# NVM Express Technical Proposal for New Feature

Technical Proposal ID	TP4146b Flexible Data Placement
Change Date	2024-05-30
	NVM Express® Base Specification 2.0b
Builds on Specification	NVM Express® NVM Command Set Specification 1.0b
	NVM Express® Zoned Namespace Command Set Specification 1.1b
	NVM Express® Management Interface Specification 1.2b
	TP4090 Deallocation Granularity Enhancement
Ratified Technical	TP4095a Namespace Capability Reporting
Proposals Referenced	TP4074a Defining Scope for Features
	TP4115 ZNS Namespace Management Enhancements
Technical Proposals in	
Development Referenced

Figure FDPEX3: Complex NVM Storage Hierarchy with Multiple Reclaim Groups

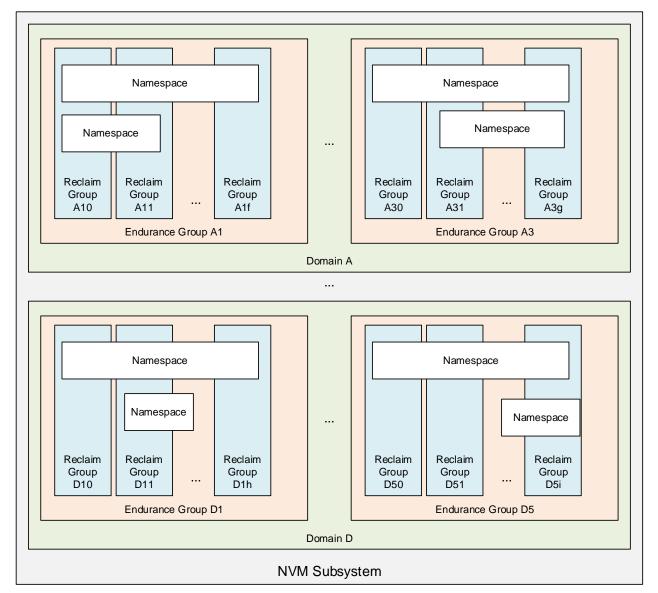
2022-09-20	Editorial items from Ross Stenfort.     From Paul Suhler:
2022-09-21	<ul> <li>Changes due to comments from Solidigm:         <ul> <li>Updated Figure FDPEX3 and text to make it cleared that the placement of user data for a namespace is directed by a host in write commands.</li> <li>Updated FDP Overview to reflect that the capacity of user data for a namespace is allocated to an RU on a write command. Tied the text to figure FDPEX3 to align to text that states the same.</li> <li>Request to rename "Placement Handle Identifier" to "Placement Handle" to separate it from "Placement Identifier:</li> </ul> </li> <li>Changes due to comments from Paul Suhler (Kioxia)         <ul> <li>editorial fixes</li> <li>Add a Get Features request to the host actions to determine the FDP events supported.</li> </ul> </li> </ul>
2022-09-22	Updated Figure ZZ with the new name Placement Handle.

- multiple domains;
- multiple Endurance Groups per domain;
- multiple Reclaim Groups per Endurance Group; and
- multiple namespaces per Endurance Group.

The placement (i.e., which Reclaim Group) of user data for a namespace is directed by each host write command to that namespace (refer to section 8.TBD).

**Figure ZZ: Flexible Data Placement Model**

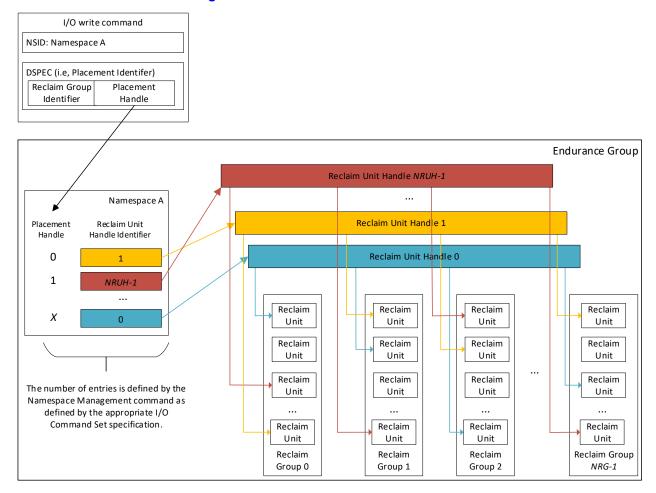
Any write command to a namespace that exists in an Endurance Group with Flexible Data Placement enabled that does not specify the Data Placement Directive uses the Placement Handle value 0h and the controller selects the Reclaim Group for that command. For example, if the write command does not specify the Data Placement Directive, then, as illustrated in Figure ZZ, Placement Handle value of 0h is associated with Reclaim Unit Handle 1h and the controller may place the user data into the Reclaim Unit associated any Reclaim Group using Reclaim Unit Handle 1h.
